## EZ-Start : Remove five minute timer

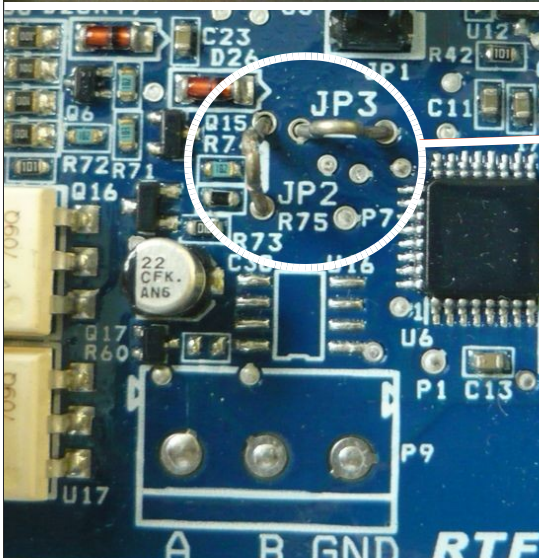
The control EZ-Start with "blue paint" board (FRM A57), have a five minutes timer inside. This timer is to prevent damage to the compressor and the start capacitor for repetitive starting. The timer remain active for five minutes after the control has lost power. If the power is applied within five minutes, the lights indicate "power failure" until the timer expires.

When the EZ-Start is used with VECO controlers this timer is not necessary, in this case is possible remove that.

Cut the jumper JP2 in the center of electric board, in this case the compressor start after a few seconds since the control is powered.

On the board there are three jumpers

JP2 is close to JP3

Cut only JP2
